MODIFICATION
ADULT RETIREMENT COMMUNITY PLANNED UNIT DEVELOPMENT (ARCPUD)
SPECIAL PERMIT PLAN
Continuing Care Management, LLC
The Willows at Medway and Whitney Place
259, 261, 261R and 263 Village Street

Purpose: Amend the previously approved ARCPUD special permit plan

DESCRIPTION OF PROPOSED MODIFICATION – The proposed plan modifications were represented on the following plan sheets prepared by Coneco Engineers and Scientists of Bridgewater, MA and provided to the Board:

PROJECT	PREPARED FOR	DRAWING
SALMON HEALTH AND RETIREMENT COMMUNITY 259, 261, 261R AND 263 VILLAGE STREET MEDWAY, MASSACHUSETTS 02053	CONTINUING CARE MANAGEMENT, LLC 1 LYMAN STREET WESTBOROUGH, MASSACHUSETTS 01581	CAMPUS DRAINAGE

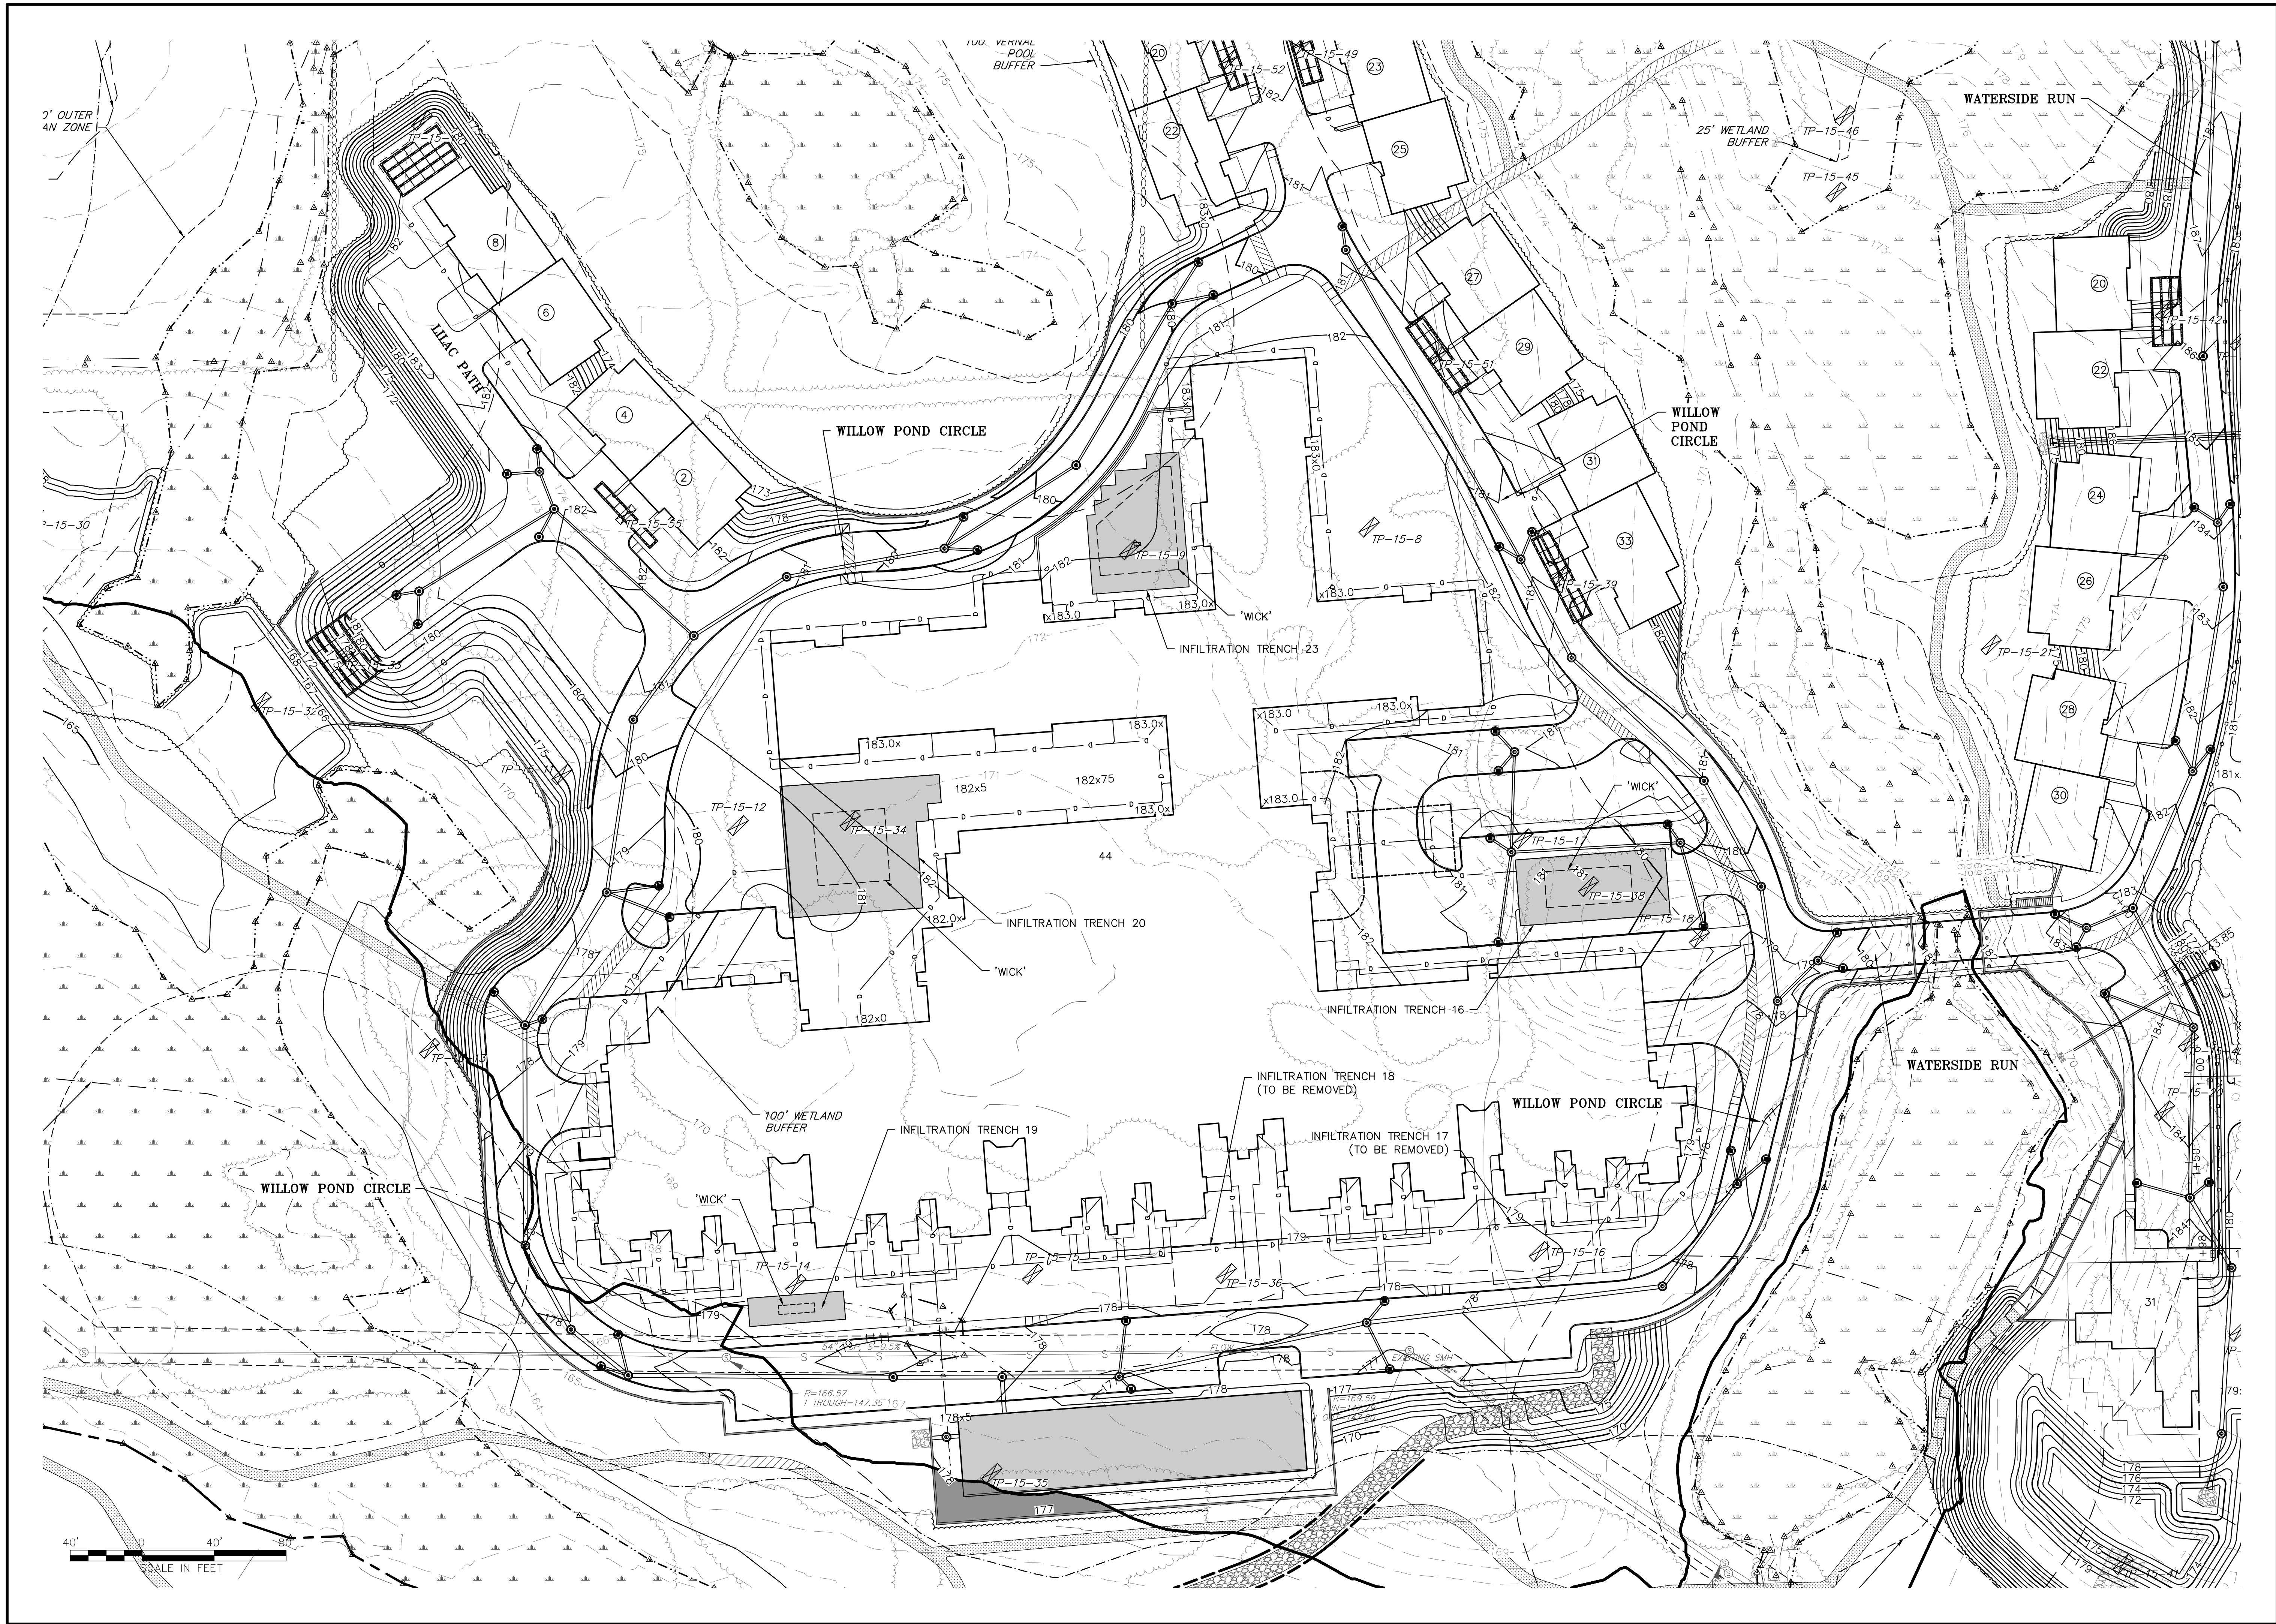
- Sheet 1 titled Campus Drainage dated 10-22-19
- Revised Sheet C24 dated 8-21-19
- Revised Sheet C25 dated 8-9-19
- Revised Sheet C26 dated 9-5-19
- Revised Sheet C27 dated 9-5-19
- Revised sheet C58 dated 11-18-19

These plan revisions reflect modifications to the installation of stormwater drainage facilities around the main campus building. The changes are needed to accommodate the structural fill that was brought in to provide necessary support for the building construction and placed below the nearby stormwater drainage infiltration facilities. The modification consists of rerouting roof runoff from the main building to alternative drainage facilities, resizing three infiltration trenches (trenches #16, #19 and #20) and removing two infiltration facilities (#17 & #18), and creating a hydraulic connection within the drainage facilities to ensure stormwater runoff is recharged to the underlying soils. The scope of the proposed changes required an amended Order of Conditions from the Medway Conservation Commission. That in turn triggered the need for a formal modification to the previously approved ARCPUD plan by the Board.
